**EB-2021-0002**  
**Enbridge Gas 2022-2027 DSM Plan**

**Interrogatories of Environmental Defence**

Figure ES-4. Natural Gas Potential

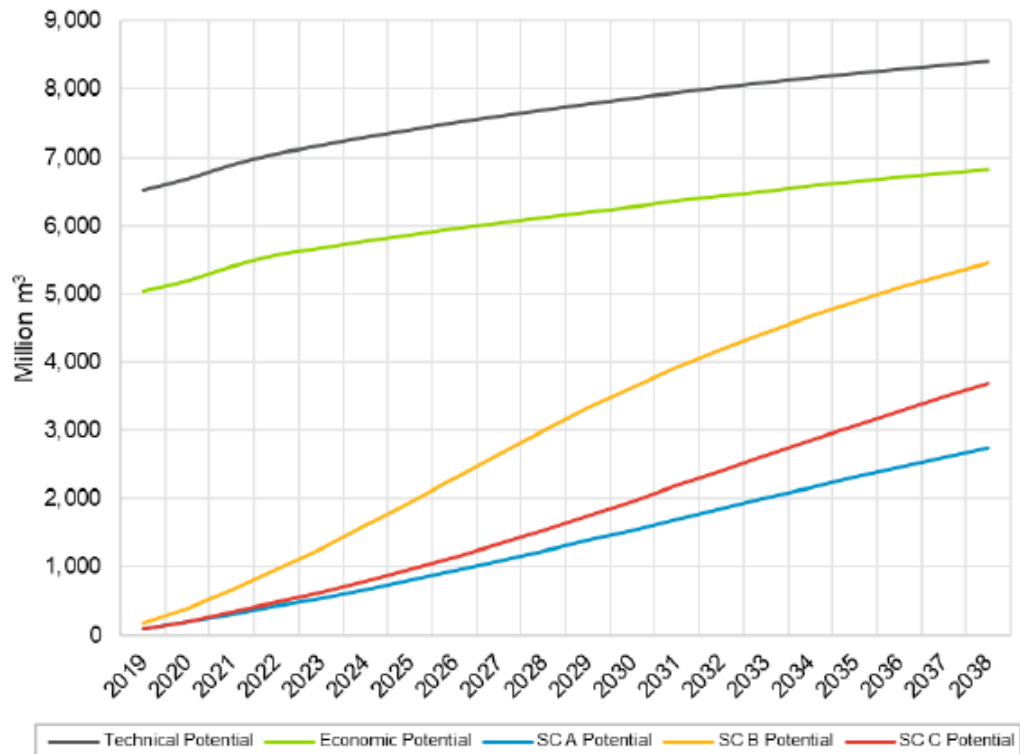
- (a) Please add a line to the following figure from page vii of the 2019 Achievable Potential Study to approximately represent the gas savings according to Enbridge’s DSM plans. Where available, please use audited results. For other years, please use forecast results based on the DSM plans (at 100% target levels). For years beyond 2027, please continue the line at the same slope as for the years 2023-2027. Please make and state any assumptions and caveats as necessary.

Figure ES-6. Natural Gas Potential – Compared with Reference Forecast

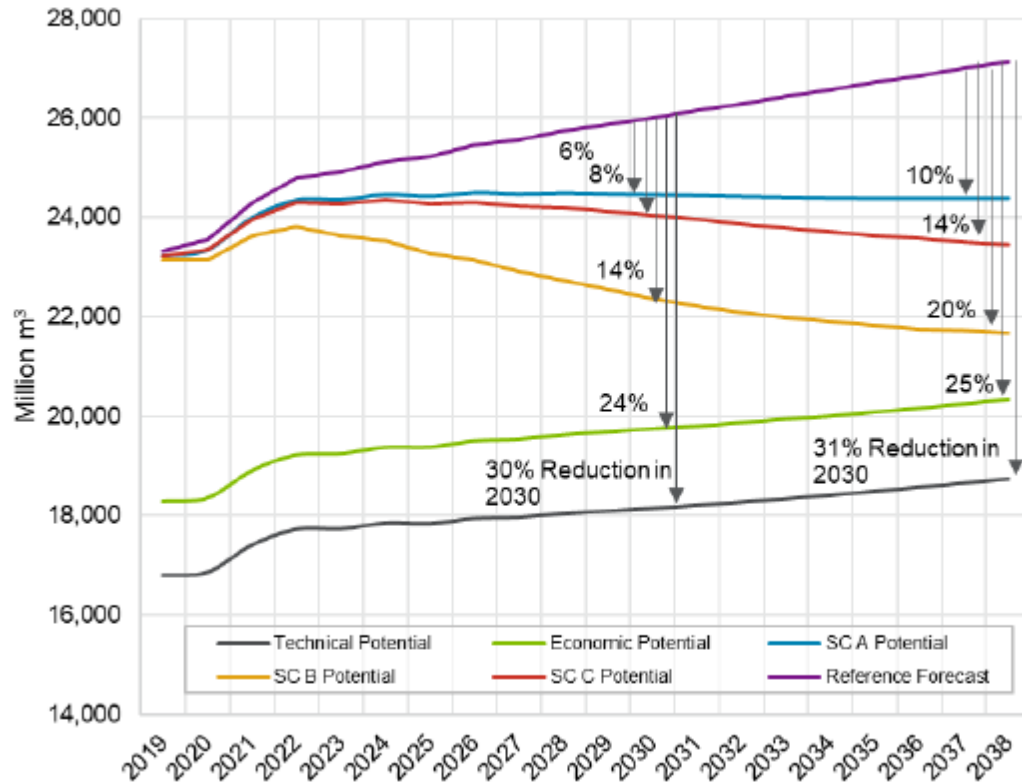
- (c) Please add a line to the following figure from page ix of the 2019 Achievable Potential Study to approximately represent the reference case minus the gas savings according to Enbridge's DSM plans. Where available, please use audited results. For other years, please use forecast results based on the DSM plans (at 100% target levels). For years beyond 2027, please continue the line at the same slope as for the years 2023-2027. Please make and state any assumptions and caveats as necessary.

Please also add another line to the following figure to show the actual gas consumption figures for the years with available data and for other years showing Enbridge's estimate for gas consumption in Ontario were there to be no DSM (i.e. akin to an updated reference case).

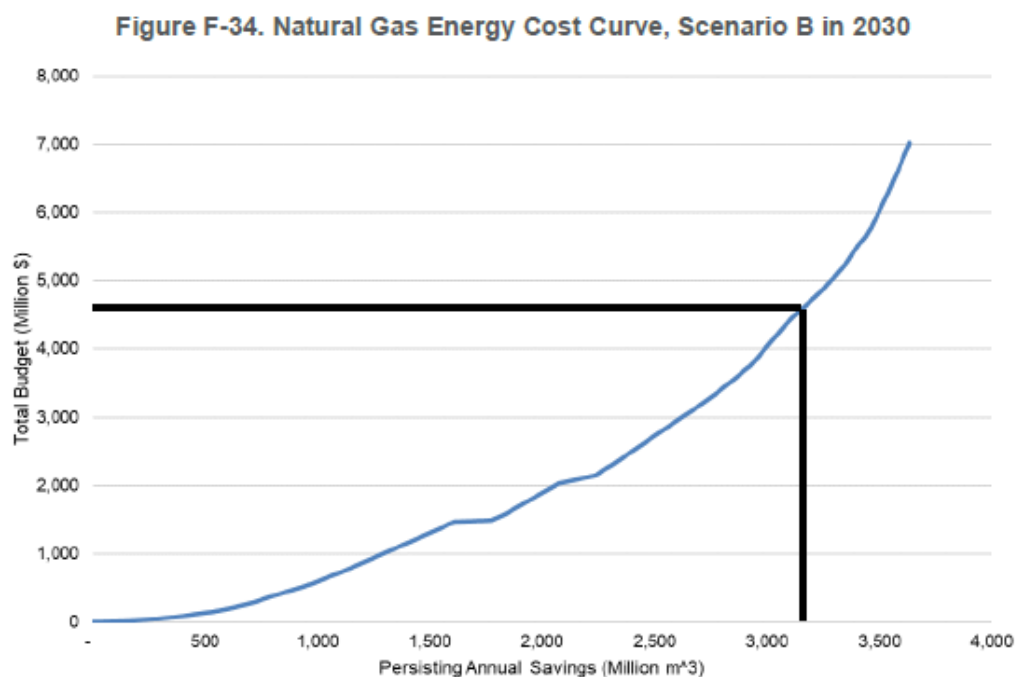
(g) Please confirm that the black line added to the following figure on page F-24 of the 2019 Achievable Potential Study approximately represents the persisting annual savings and budget level that would correspond with Ontario’s Environment Plan ([link](#)). If Enbridge does not know or believes this is false, please check with the authors of the report and the Board Staff involved in the commissioning of the report.
